CITY OF CODY
PLANNING, ZONING, AND ADJUSTMENT BOARD
TUESDAY SEPTEMBER 10, 2019
CITY HALL COUNCIL CHAMBERS @ 12:00 NOON

SITE DEVELOPMENT PLANS FOR HAMPTON INN & SUITES CODY, WYOMING

**CITY OF CODY
PLANNING, ZONING AND ADJUSTMENT BOARD
STAFF REPORT**

SITE PLAN

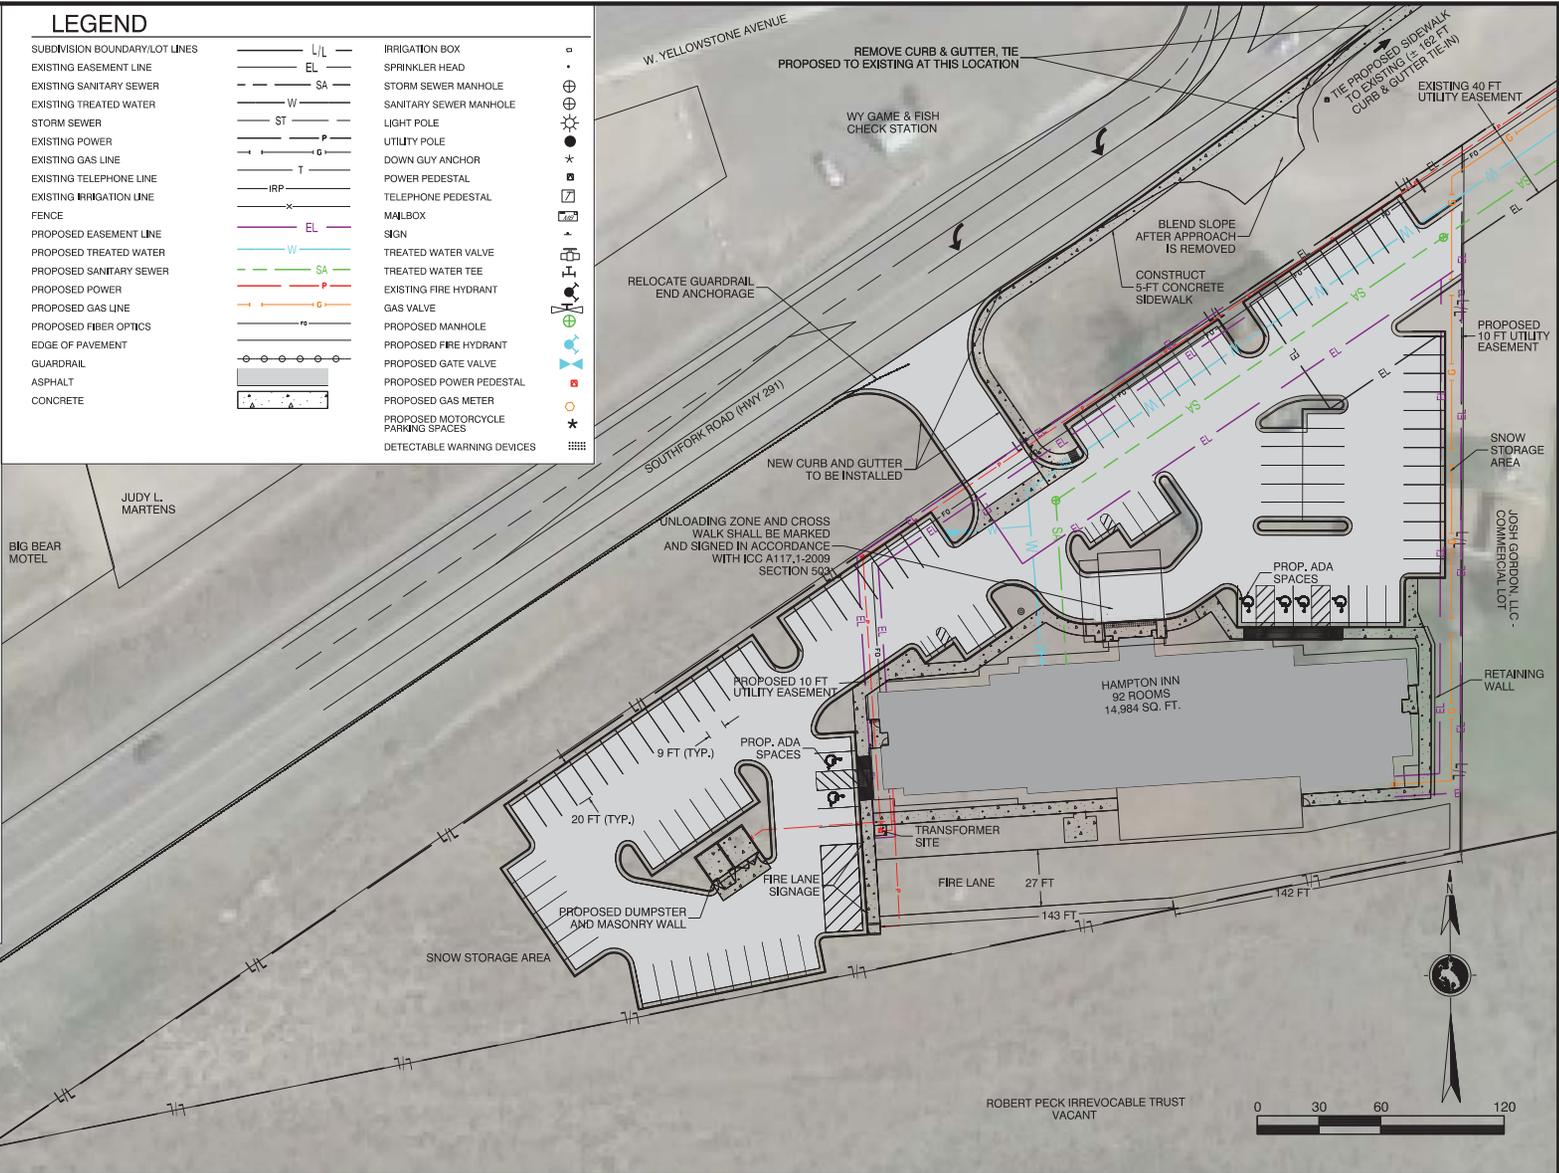
The access plan is indicated in concept on the site plans—it involves relocating the existing approach about 160 feet to the south (100 feet further than indicated in the January review) and converting the inside, southbound lane to a turn lane into the site. Curb, gutter and sidewalk will be extended from the north, southward into the property and the area between existing asphalt and the new curb will be paved.

- 12. Clarification—the fire lane is required as shown on the civil site plans—not the shorter length shown on the architectural site plan (A12.1).
- 13. The fire marshal has been occupied with fires, and I have been unable to confirm if he is requiring painted curbs and/or “No Parking/Fire Lane” signs in addition to the two signs shown. Paint and/or mark curbs as required by the fire marshal.

- 14. Provide a rolled curb for the fire lane, and indicate its construction detail on plans.
- 15. Applicable city utility fees are to be paid with the building permit fee.

With the elimination of the existing approach, the existing curb and gutter will be removed around the radius back to a point along the merge lane. The developer is also planning to extend sidewalk from the new approach to the end of the existing sidewalk east of the property. These plans are shown generally in this plan set but will be shown in detail on the plan set being prepared for WYDOT's review.

DRAINAGE PLAN

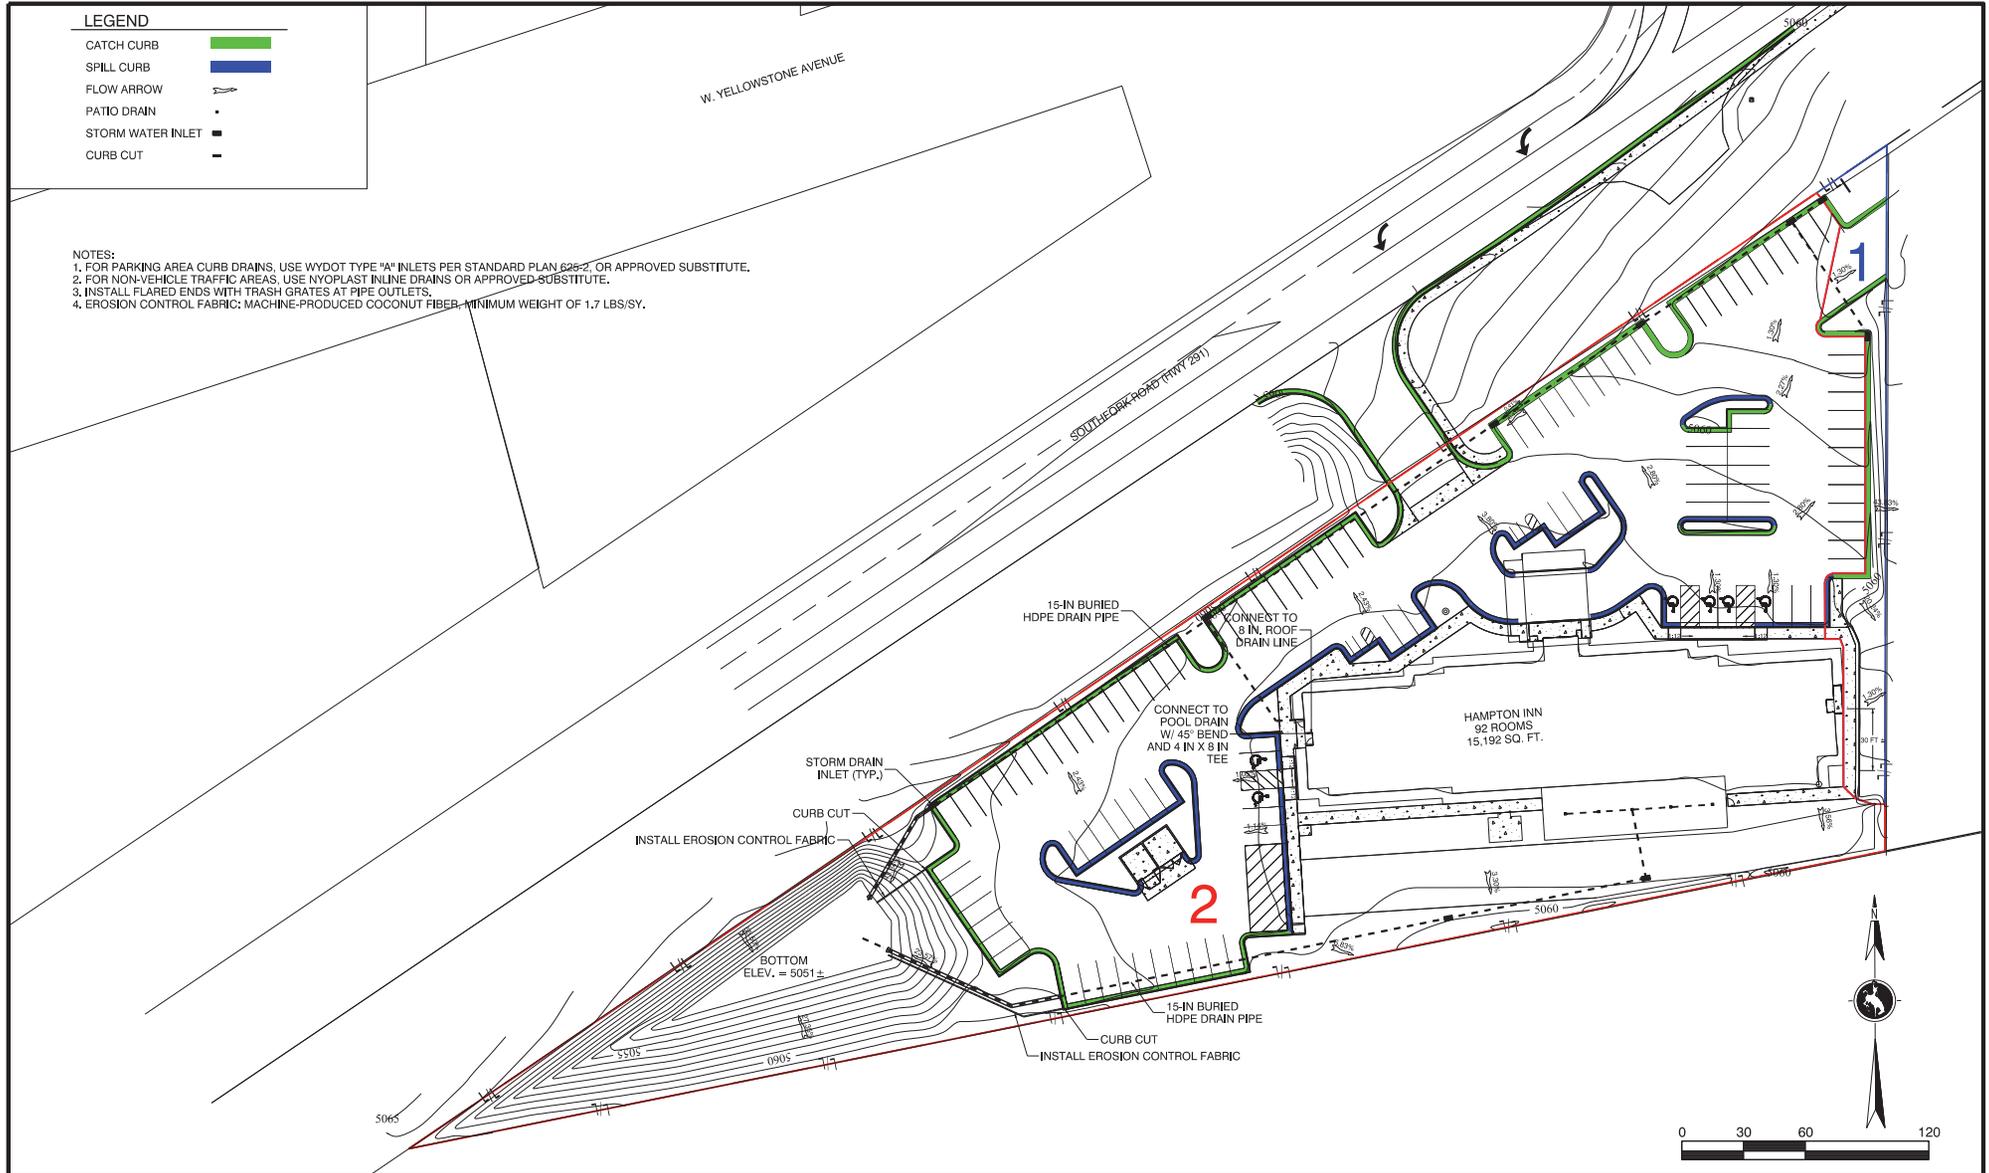
An analysis of the storm water was provided by the applicant's engineer. The storm water will be managed as noted in the grading and drainage plan (Sheets 3 and 4) and the updated drainage report (revised Aug. 22, 2019). The roof drainage, patio drainage, and much of the parking area will be collected through a series of inlet grates, curb cuts, and 15-inch pipe throughout the site and piped to an open swale at the southwest end of the property. The swale is sized much, much larger than the minimum required, which is good because there is the possibility that it will also intercept some drainage coming off of the highway.

From the landscaping plan, it appears that the sides of the drainage swale will be lined with a native grass mix (non-irrigated). To minimize the erosion potential there are some stabilization mats proposed. Staff recommends also that the slope be modified to roughly a 3:1 slope to further minimize erosion potential. As one side is effectively 4:1 and one side 2:1 now, it is simply a matter of using the average 3:1 slope on both sides. Also, the outlets will need grates to prevent animal entry, and rock to dissipate energy from the flowing water.

7. Provide grates and energy dissipation/erosion control structures (i.e. rip rap) at the ends of the storm water pipes.
8. Provide a utility easement for the electrical and telecommunication extensions, as shown on the plans, prior to activation of the utilities. Any freestanding sign will need to be relocated outside of the City electric utility easement—modify the plan (Sheet E1.0) accordingly.

The runoff will now be directed to a storm sewer system consisting of inlets and pipe. Details for all sections have been added to the plan set.

Details have been added, and as mentioned above no modifications are proposed for the right-of-way.

SITE PLAN - ELECTRICAL
E1.0

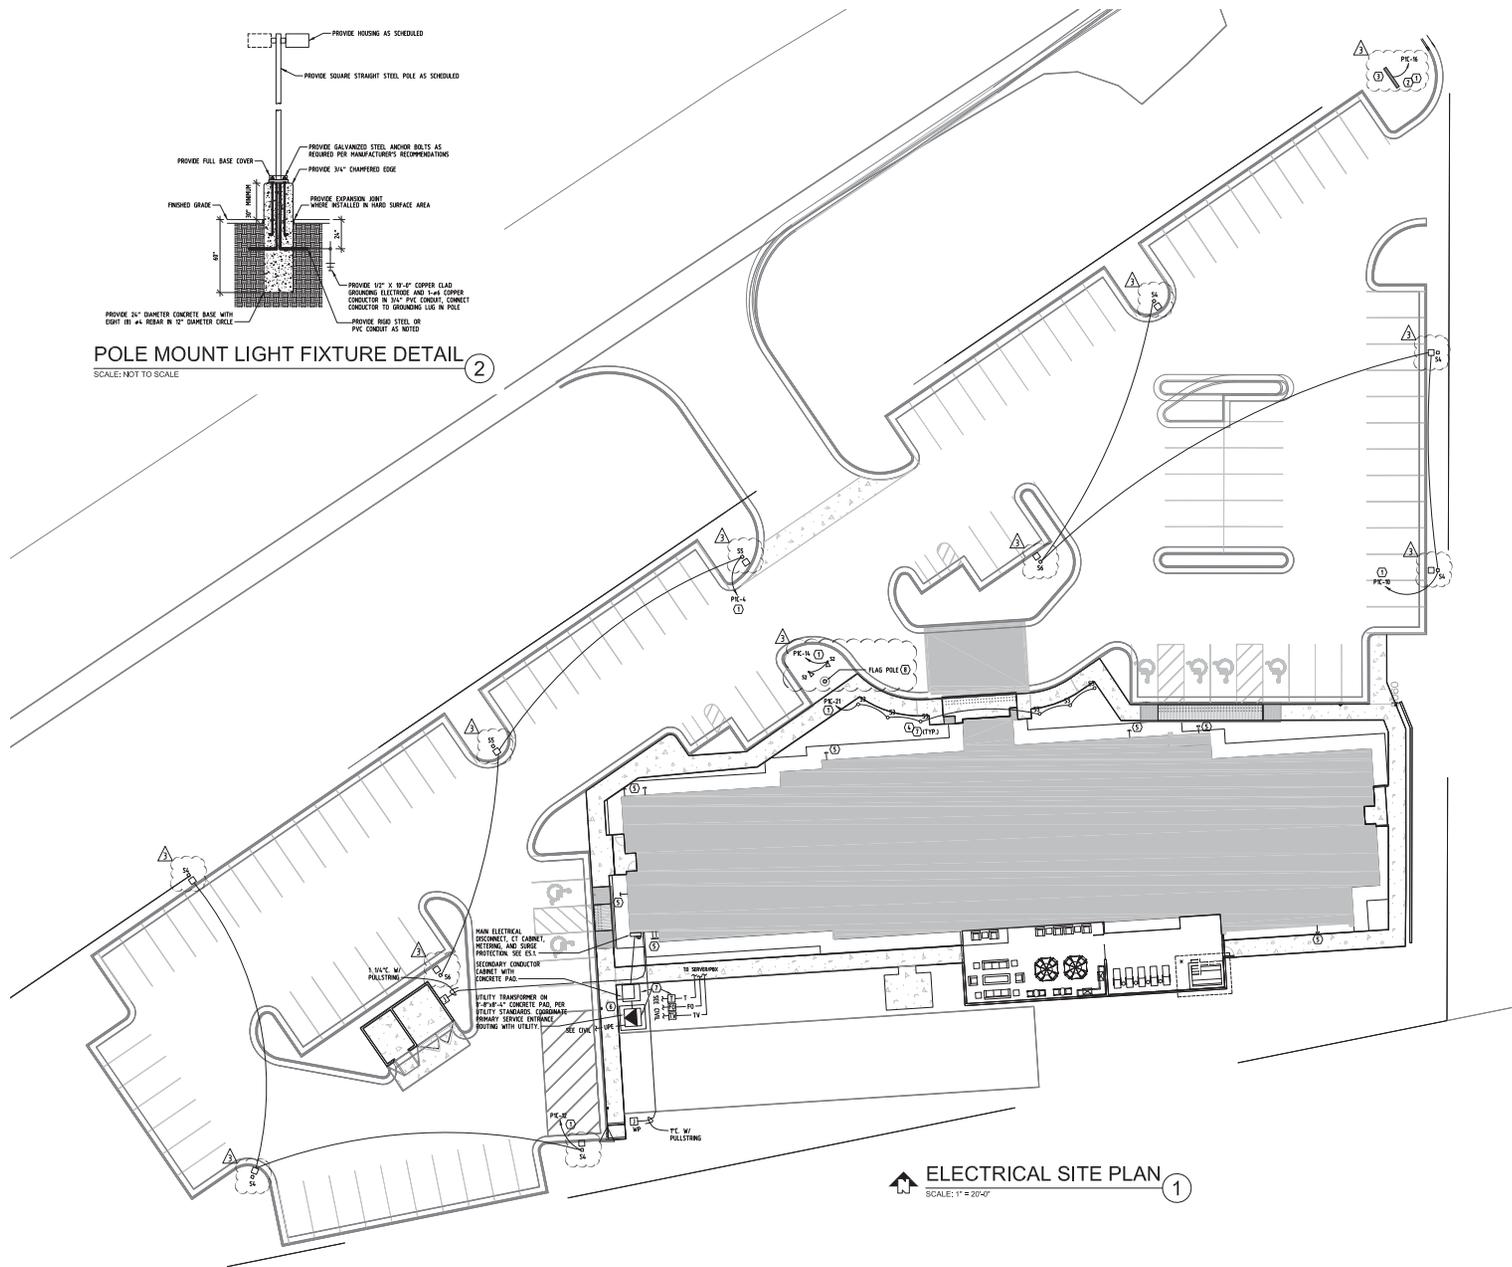
A sign application is not included. The exterior signage will require review and permitting at staff level. It is noted that the monument sign location shown on Sheet E1.0 is directly over the proposed power line. Public Works does not allow signage in their easements, so the sign will need to be shifted. WYDOT doesn't allow sign supports in their right-of-way either.

14. Update Sheet E1.0 and E1.1 to detail the correct transformer and utility box locations, reflect the modifications to the parking lot in the northeast area, and remove the monument sign from the WYDOT right-of-way (unless permitted otherwise by WYDOT).

Plan View
Scale - 1" = 20ft

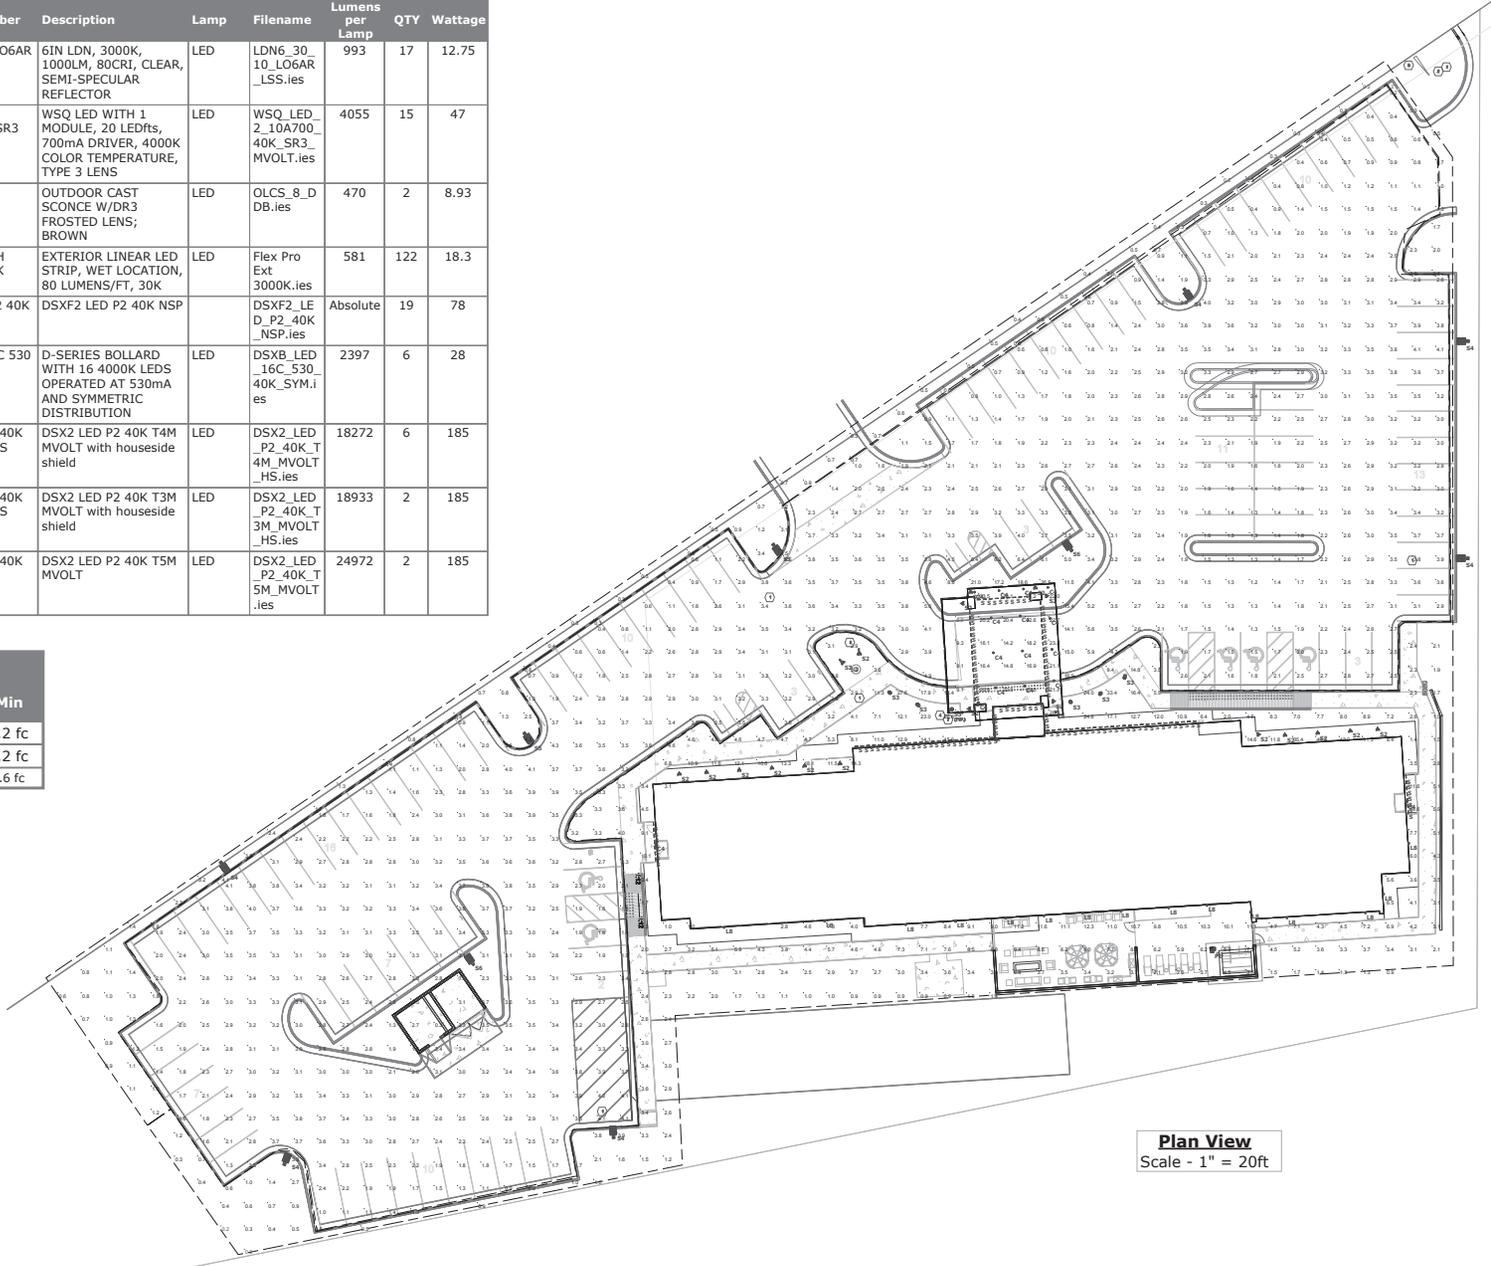
The overall lighting plan clearly illuminates the project, but does not result in excessive light spillage beyond the property lines, other than in the immediate area along the east side. As the spillover is fairly minimal and that area is also commercial, it is not of concern to staff.

The only modification staff has identified that could be considered to further minimize the lighting impacts from the project is to use a "warmer" light. The International Dark-Sky Association notes that light with a temperature of 4,000 kelvin or more has excessive blue light, and recommends the use of light fixtures that produce a warmer light of 3,000 kelvin or less (publication attached). The Hampton Inn plans call for use of exterior lights of 4,000 kelvin. Blue light from the proposed LED light fixtures, like other sources of blue light (computer screens, electronic devices) can affect sleep and health. If the developer wishes to claim full compliance with Dark Sky standards, whether for marketing or other purposes, the change would be needed. Staff is not to the point of recommending a change in the lighting plan, but felt sharing the information is appropriate.

Revised Preliminary Plat

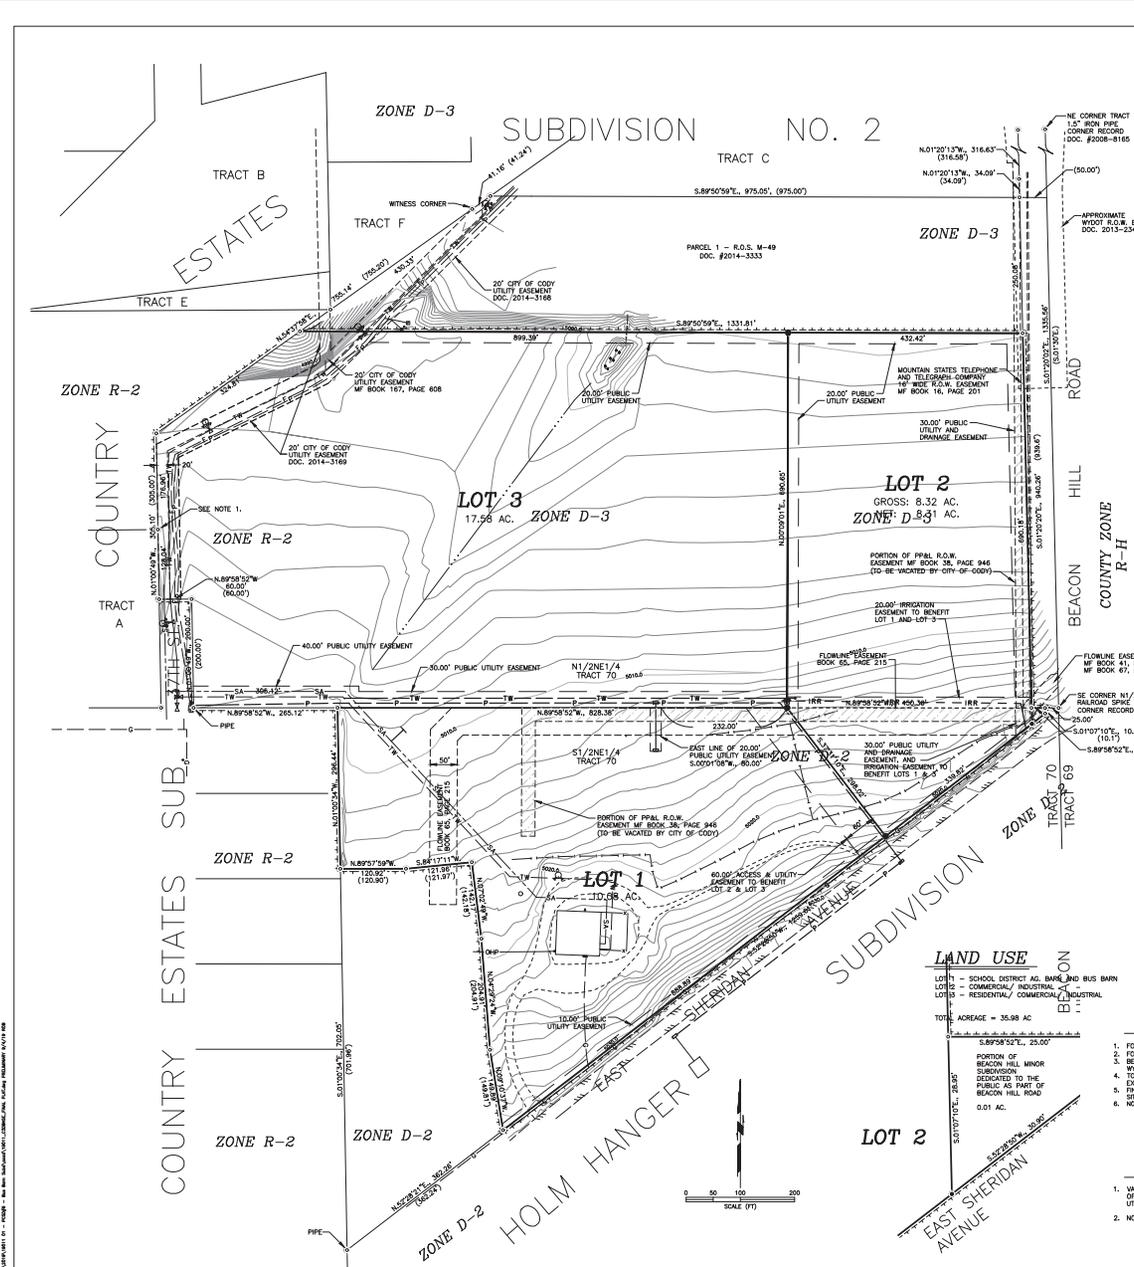
- c. Include language in the "Certificate of Owner" that the owner of Lot 1 agrees to dedicate the 60' access easement as public right-of-way at no cost to the City upon the request of the City.

- d. Remove "East" from the Sheridan Avenue label.
 - e. Correct the legend and perimeter lot corners to show placement of brass caps, as required by City of Cody Code 11-5-1(B)(3).
